ARBORICULTURAL REPORT FOR SHACKLETON STREET BASSENDEAN

1.3 Project Brief to identify suitable trees for Shackleton Street median island plantings.

The Town is seeking an Arborist to inspect Shackleton Street and evaluate the proposed road layout drawing TOB5-2017-30 Sheet 1 of 15 using the above Council adopted street tree selection criteria and in addition consider the following median island criteria:

Figure 2. Approximately 26 trees are proposed for installation within the central median traffic islands, and include individual trees as well as groups of two, three and four trees.

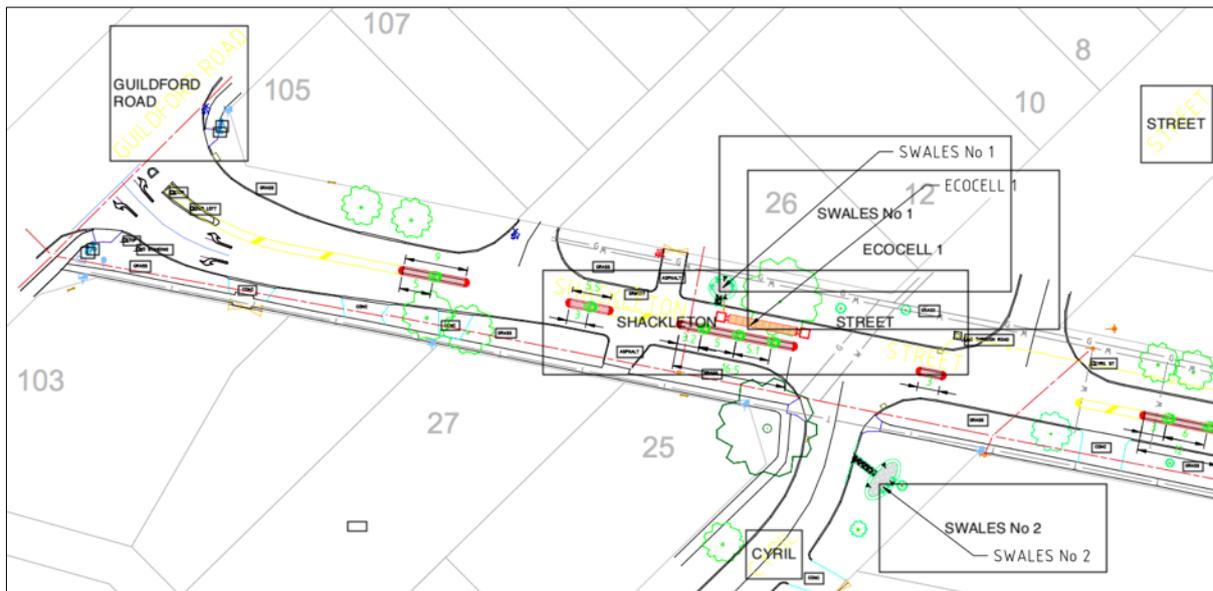
- 4. Tree protection:** Central island protection measures are required to alleviate the potential for collision injury and/ or stem breakage following vehicle impact. The use of bollards (wood or steel) at the median island ends and preferably several metres from each tree is expected to be sufficient to mitigate the potential for vehicle follow-through damage in the event of collision, and together with concrete kerbing, generally provides sufficient protection for advanced trees in residential streets with low speeds i.e. <50 km/h.

5. **Species selection:** The selection of an appropriate species for the location provides the best approach to mitigate tree/ infrastructure conflicts into the future. With 1.2m identified as the central median width, tree selection should seek to specify a species that attains a trunk diameter at maturity of approximately 50cm. Where a larger species is desired for shade and other tree-related benefits, an allowance (expectation) must be made for future median repair/ modification/ increase in width as the tree matures. The tree selection process should also avoid species known to possess a vigorous rootplate such as *Casuarina* spp., *Ficus* spp., *Tipuana tipu* etc.

Figure 12. Placement of trees several metres away from the ends of the central median islands provides another technique to mitigate the potential for tree damage/ loss resulting from vehicle impact, and in doing so may reduce the total number of trees identified in the original design.
